**Upper Harbour Drive TMP Safety Assessment**

This safety assessment has been prepared by Beca Limited (Beca) for Auckland Transport (AT) in response to a request for an independent safety review of the cycle lanes on Upper Harbour Drive. We understand that there have been issues with vehicles colliding with concrete separators between cycle lanes and the traffic lanes on Upper Harbour Drive. We understand that temporary traffic measures have been currently put in place for an interim period, however there is concern as to whether the temporary traffic measures within the Traffic Management Plan (TMP) are sufficient and safe in the current environment.

Figure 4. Lane width measurement locations on Upper Harbour Drive.

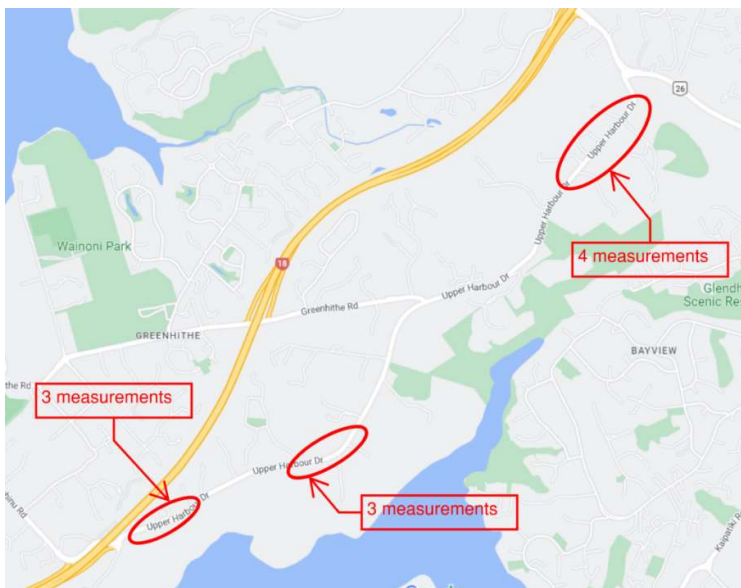
- Lighting – the route was well-lit, with the traffic cones delineating the concrete separators being visible at night.
- Line marking – some line markings were faded near the northern section of Upper Harbour Drive.
- Lane width – The lanes felt very narrow when driving along Upper Harbour Drive. On-site measurements showed most lane widths were 3.0-3.1m, in some locations up to 3.2m. These measurements were taken from the edgeline to the centreline, or to the edge of the flush median where this was present. The location of measurements taken is shown in **Figure 4**.
